**CONSTRUCTION BULLETIN
No. 1**

Institution: Calipatria State Prison - CAL

Reference: Project #18-045, Replace Roof, Phase 11, including

Description: This bulletin is to revise the roof slope to the existing ¼” per foot and to revise the parallel AHU’s crickets to 1 ½” per foot on the upper roof per RFI 003 response. Plans and Sections have been revised show the updated roof slope. Parapet,

OF # SHEETS V1

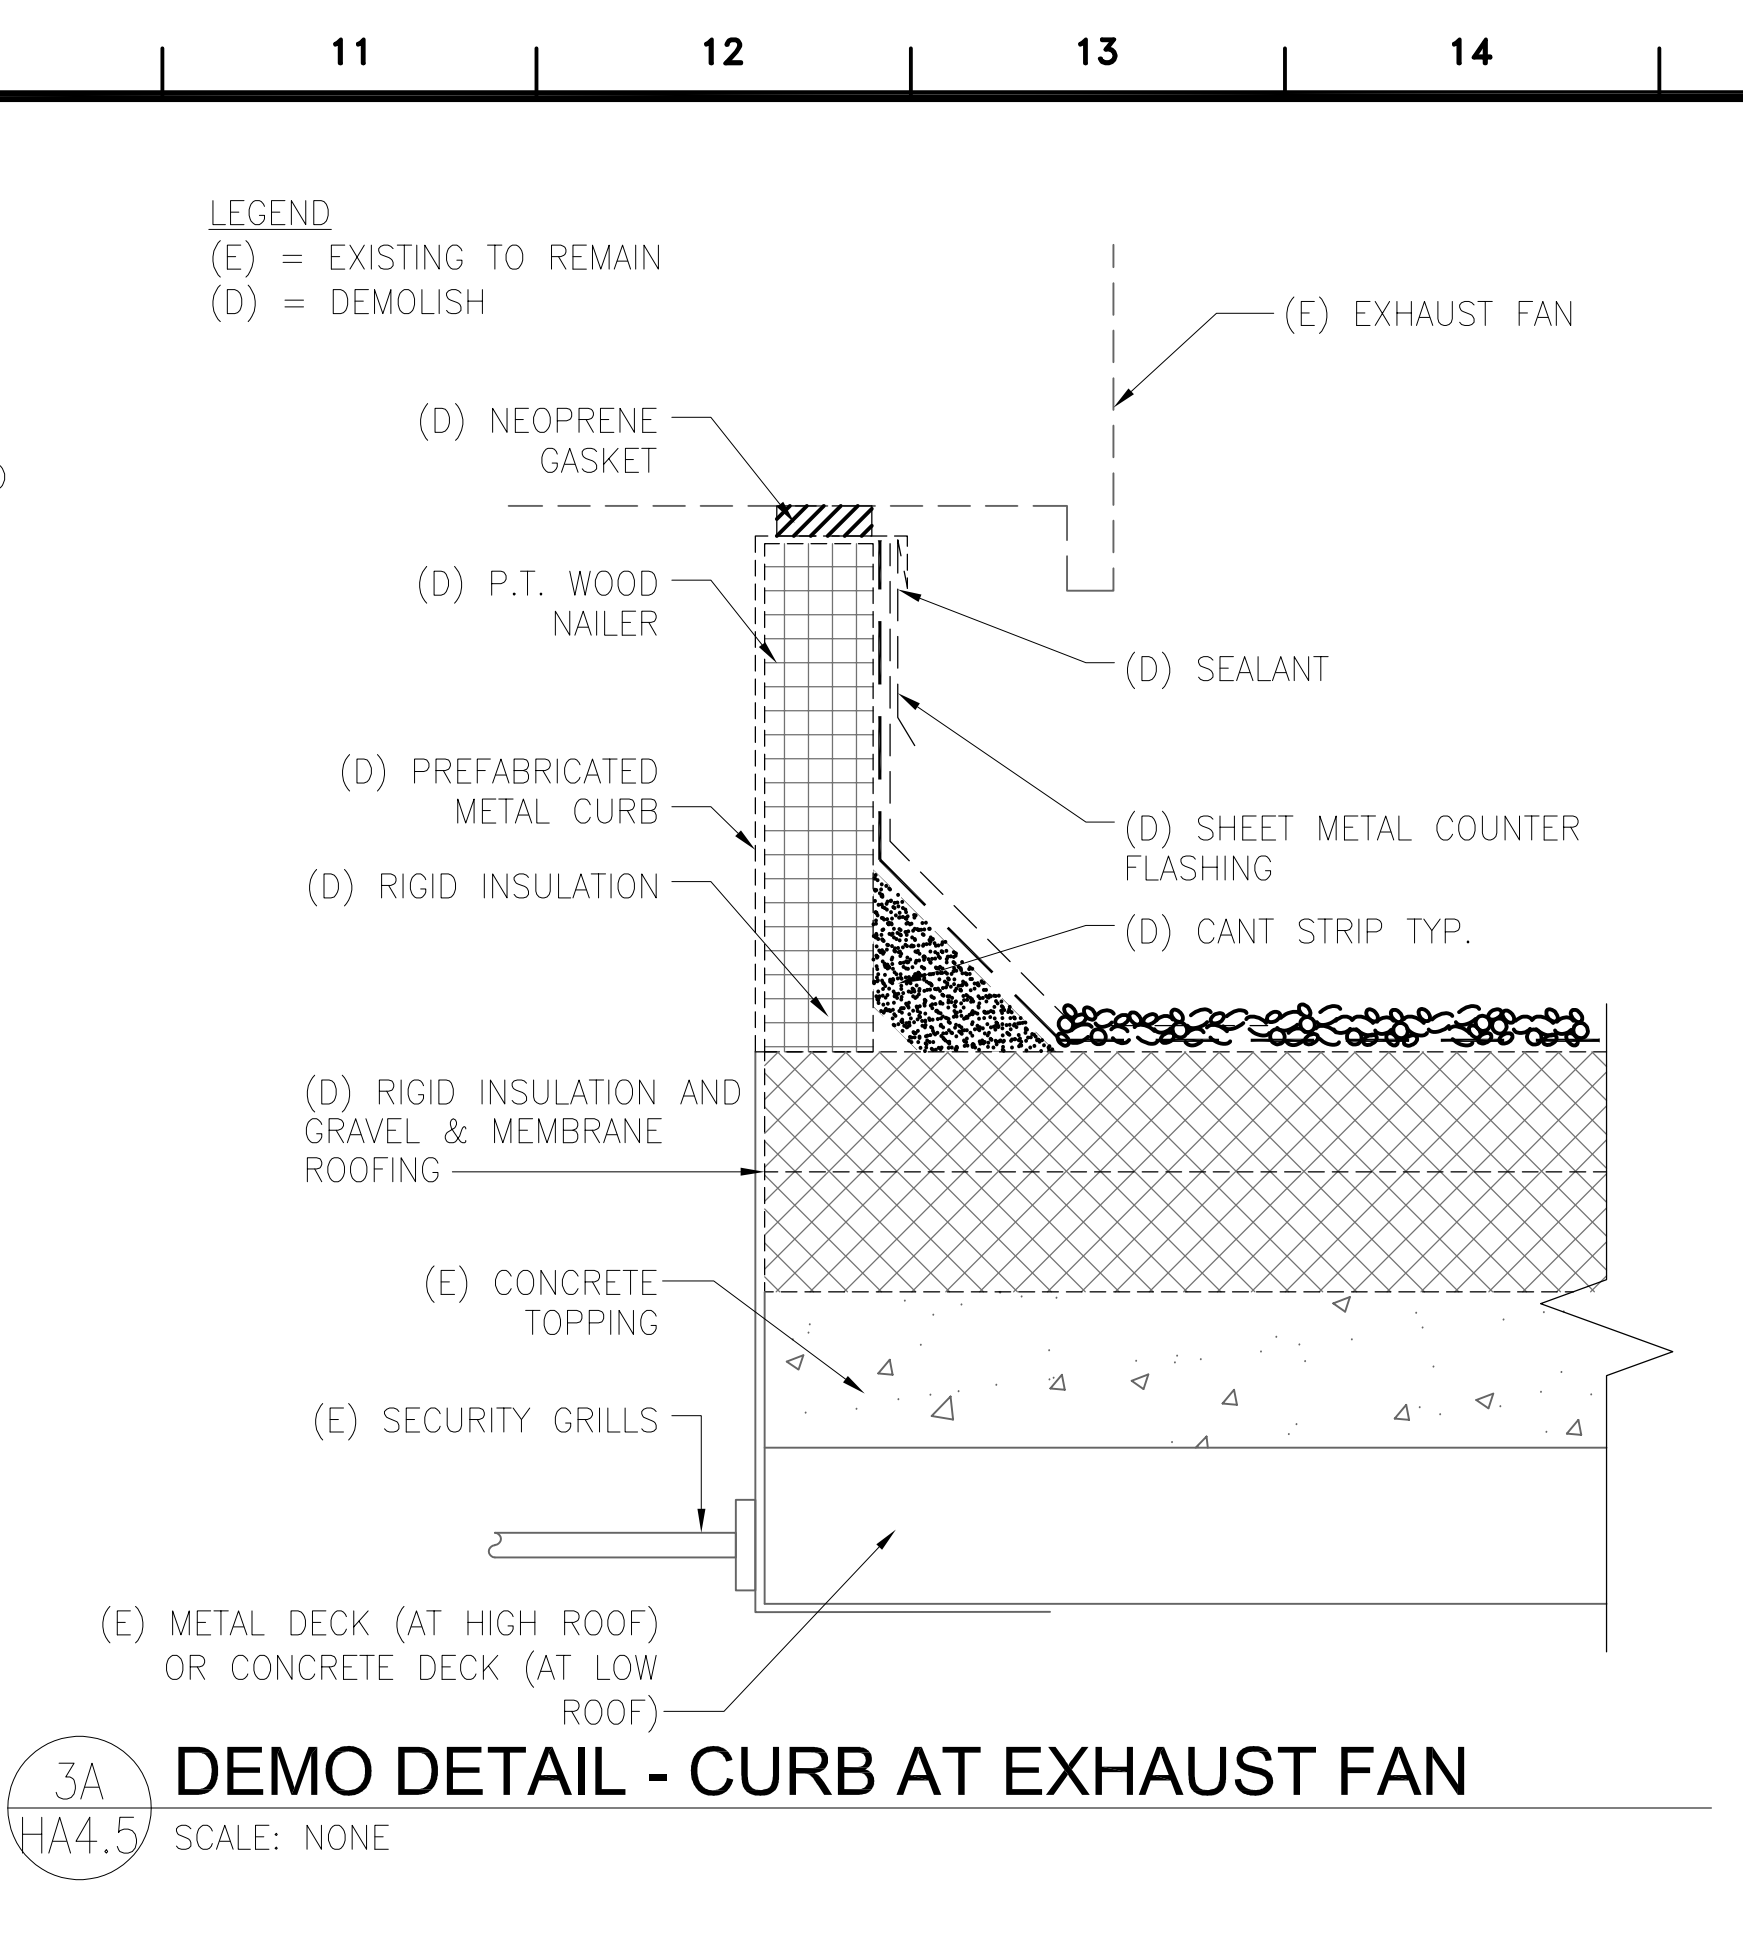
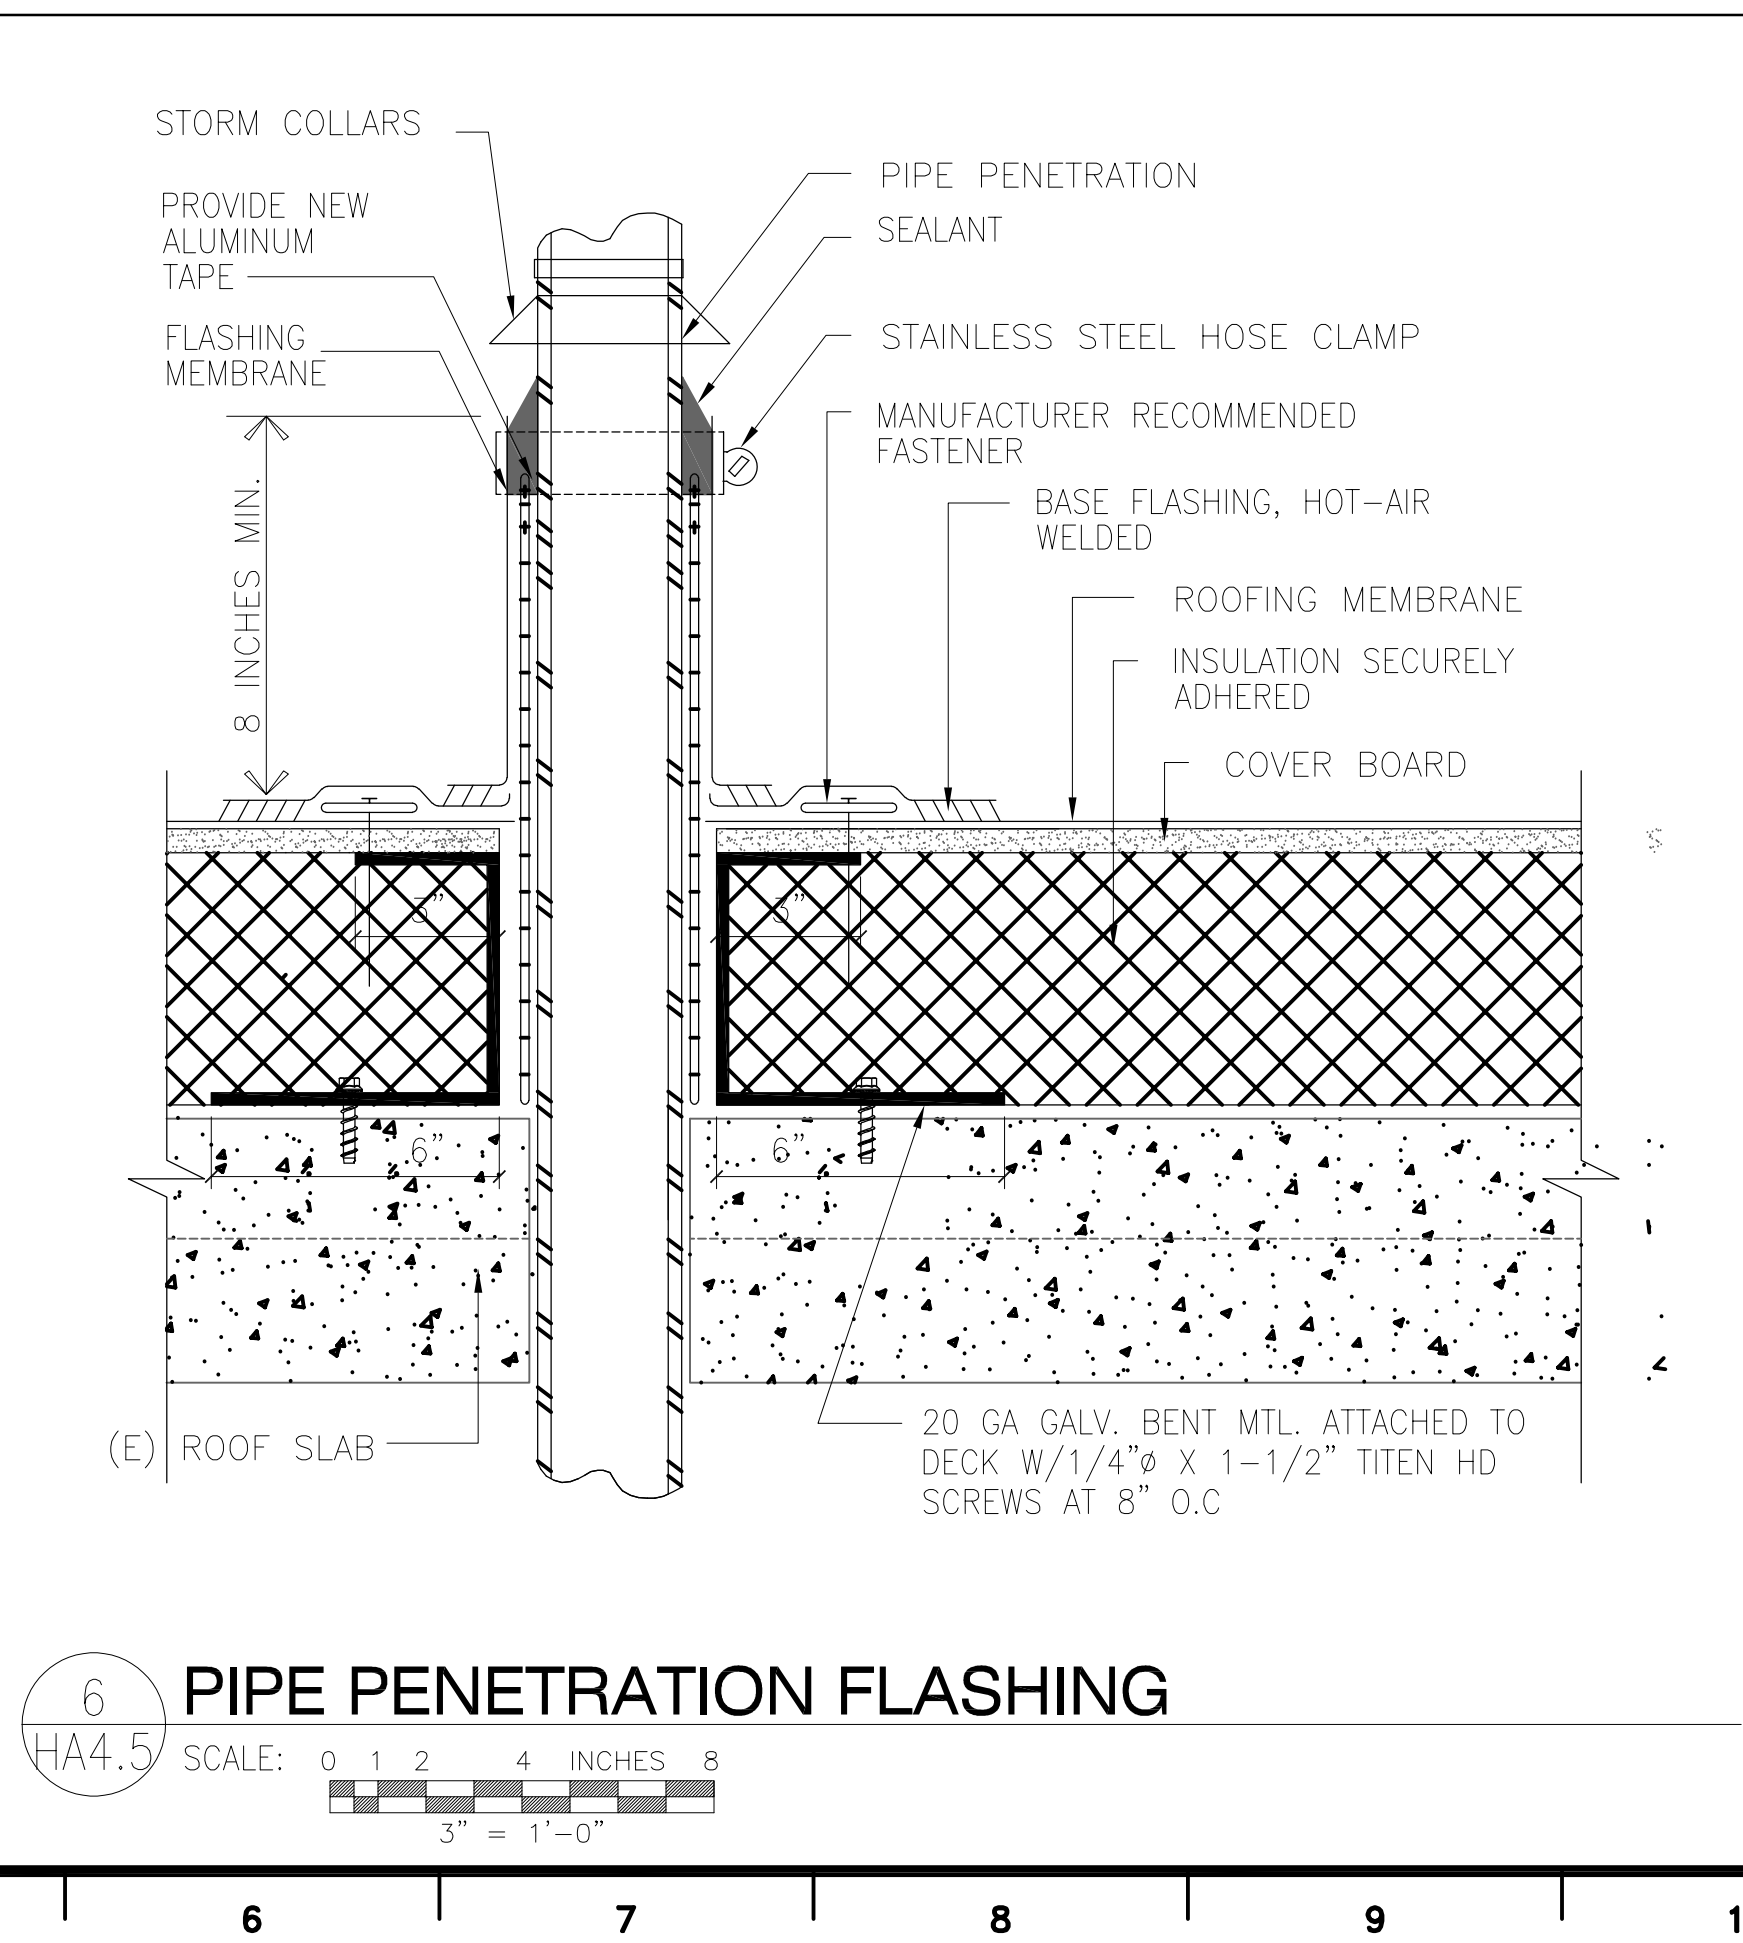
- c. Revised Guardrail slope and top of roof elevation per roof slope revision, see D/HA3.3
16. Sheet HA4.1:
 - a. Revised parapet detail to reduce parapet height per reduction of roof slope. See detail 1B/HA4.1.
